Well Name: RED HILLS WEST 22/15 FED COM	Well Location: T26S / R32E / SEC 22 / SESW /	County or Parish/State:
Well Number: 571H	Type of Well: OIL WELL	Allottee or Tribe Name:
Lease Number: NMNM027507	Unit or CA Name:	Unit or CA Number:
US Well Number: 3002552226	Well Status: Approved Application for Permit to Drill	Operator: MEWBOURNE OIL COMPANY

Sundry ID: 2764446

Type of Submission: Notice of Intent	Type of Action: APD Change
Date Sundry Submitted: 12/05/2023	Time Sundry Submitted: 08:41
Date proposed operation will begin: 03/05/2024

Procedure Description: Mewbourne Oil Company requests permission to: Change the name of the RED HILLS WEST 22 H3MD FED COM 1H to the RED HILLS WEST 22/15 FED COM 571H Perform BOPE break testing and offline cementing as detailed in the attached documents See attached C102 and variance documents

WELL LOCATION AND ACREAGE DEDICATION PLAT

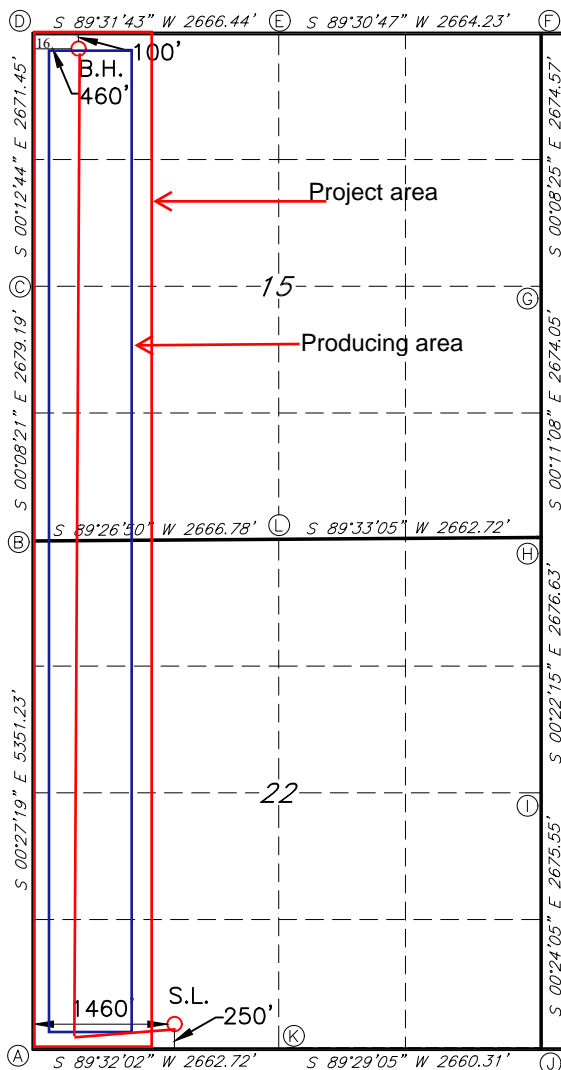
REV: NAME & BH CHANGE 07/28/22
